## 2. CORRECTIONS AND ADDITIONS

As required by Section 15088(d) of the CEQA Guidelines, this chapter provides corrections or clarifications to the Draft EIR. None of the corrections and additions constitute significant new information or substantial project changes, as defined by Section 15088.5 of the CEQA Guidelines, and thus, recirculation of the Draft EIR is not required. The changes to text and graphics contained in the Draft EIR are indicated below under the corresponding Draft EIR section heading. Deletions are shown in ~~strikeout~~ text and additions in underlined text.

Figure 2.4 (Modifications to Project Footprint since IS/MND) on page 2-9 has been revised as follows to indicate the correct limits of construction work on the 1<sup>st</sup> Street Bridge:

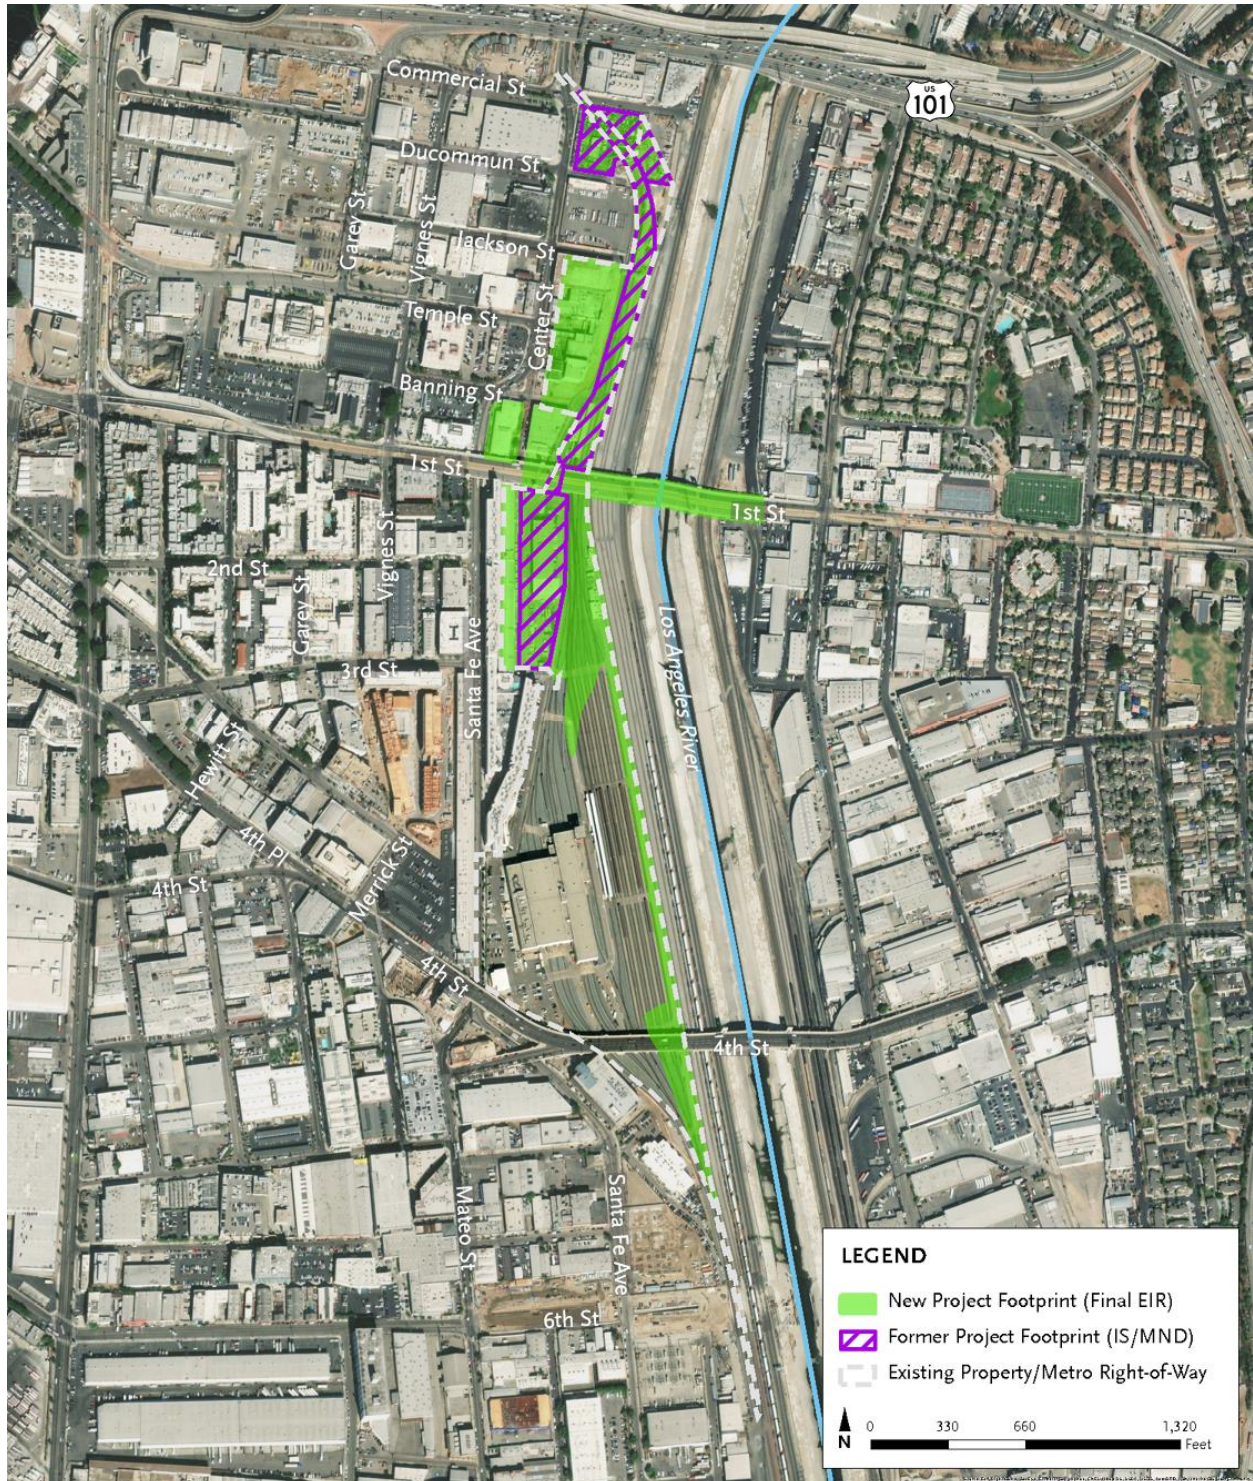
Figure 2.3 (Project Components) on page 2-7 has been revised to match the revised map on page ES-5 to indicate the correct limits of construction work on the 1<sup>st</sup> Street Bridge.
